Development Review Committee Comments | 5/17/2022
Case PLAT22-0021
Holder Smithfield Estates (8609 Timber Drive)

WRITTEN STATEMENT OF CONDITIONS

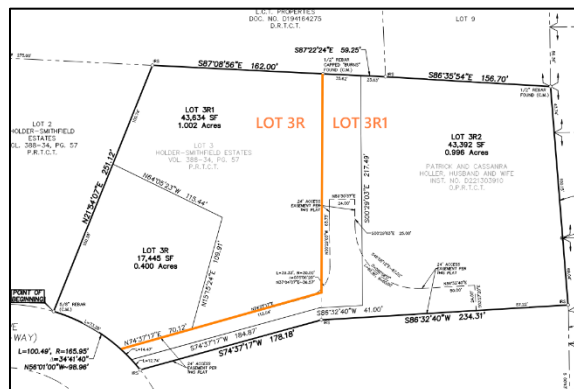
1. Informational. A zoning change application was submitted for this property in conjunction with the subdivision plat. The review of the plat was based in part on proposed zoning of R-1 (Single-Family Residential). *NRH Subdivision Regulations §110-384 (Conformity with zoning regulations)*
2. The proposed lots do not conform to the minimum lot frontage standards of the proposed R-1 (Single-Family Residential) zoning district. Revise the plat to reduce the number of lots to two (2) lots as shown in the exhibit below, with the common lot line coinciding with the existing tract boundary.

The Development Review Committee (DRC) will recommend denial of the three-lot plat as proposed. The existing property only has 100 feet of street frontage, which is not sufficient frontage for more than one standard lot zoned R-1 (Single-Family Residential). The zoning ordinance and subdivision regulations could allow for a lot to provide only 50 feet of street frontage, and this standard has been applied in other flag-shaped lot arrangements.

The DRC could support and recommend approval of a two-lot plat with a waiver to allow for one lot to have 25 feet of street frontage due to the unusual shape and depth of the existing property.

The three-lot plat may be approved only if a waiver is granted by the Planning and Zoning Commission and City Council to this standard. In order to consider a waiver, the applicant must submit a letter stating the grounds for the request and describing the special conditions or circumstances causing hardships that justify the waivers being requested. Additional information is available online at [Subdivision Regulations Section 110-42](#).

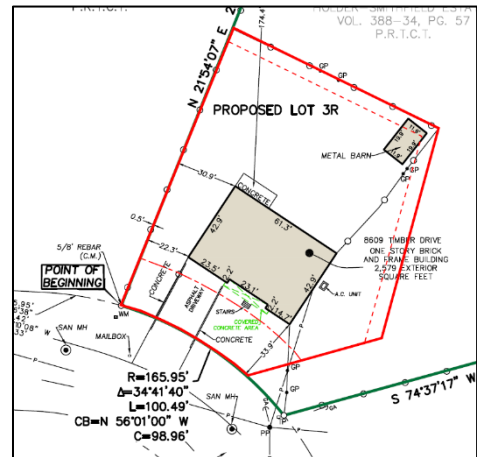
3. The exhibit showing the existing structures on the property shows that a nonconformity will be created by the proposed dimensions of Lot 3R. The existing metal barn will encroach the required 7.5-foot utility easement as well as the required zoning setbacks for permanent accessory structures. As such, the lot cannot be created as proposed unless one of the following occurs:

- a. Revise the proposed lot lines for Lot 3R to meet all required setbacks and encroachments for the accessory building;
- b. Demolish and remove the accessory building prior to plat filing; or
- c. Provide a letter requesting and justifying the creation of a nonconformity on the lot. This is subject to review and approval by the Planning & Zoning Commission and City Council.
